Construction and Stormwater Inspection

Operator: VERDAD RESOURCES LLC - 10651

Location ID: 457136

Location Name: ROHN 9-60/14A

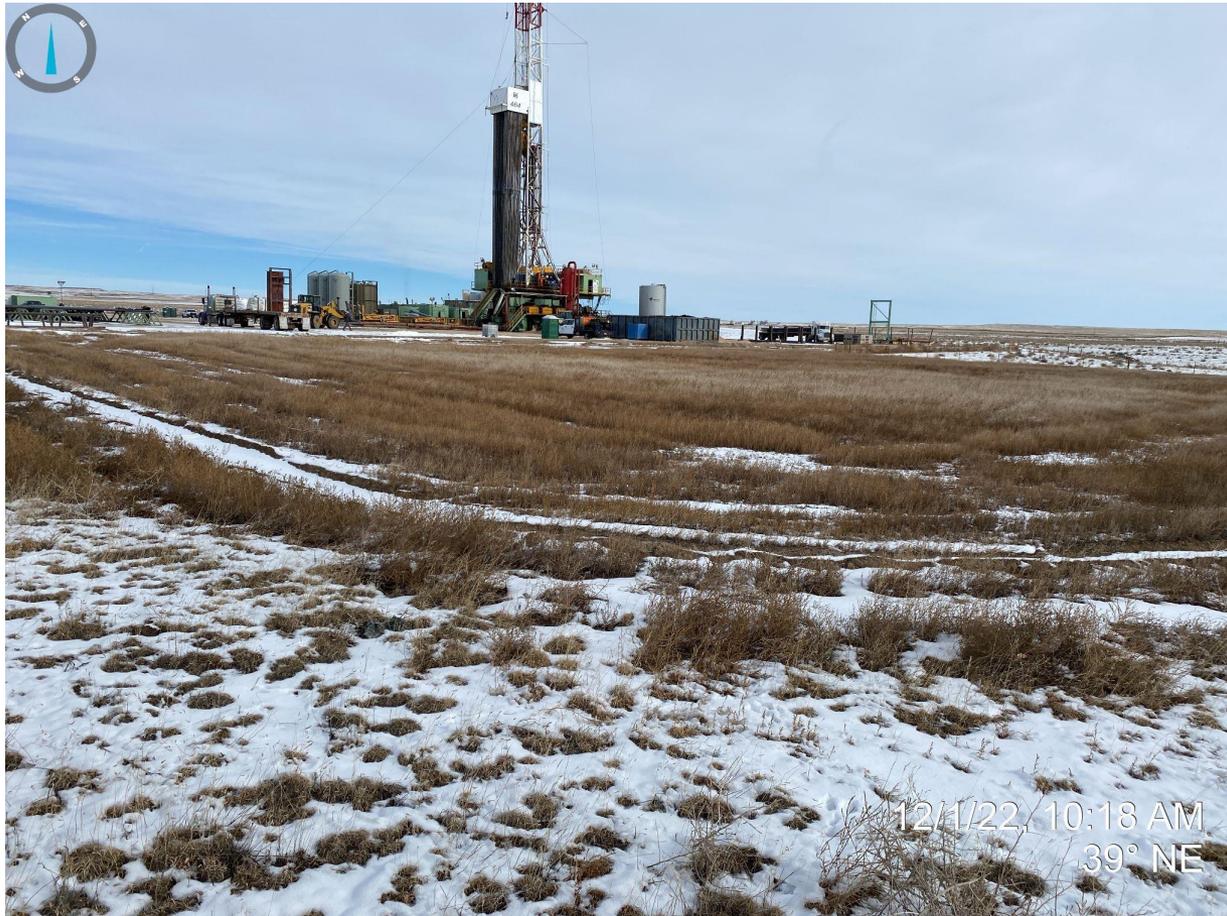
Photo 10. Taken from the southwest corner of location, facing northeast. Photo illustrates presence of undesirable vegetation (e.g. russian thistle and kochia) in a portion of the interim area of the location. A follow-up interim reclamation inspection will be conducted at a later date to ensure compliance with 1003 Rules.
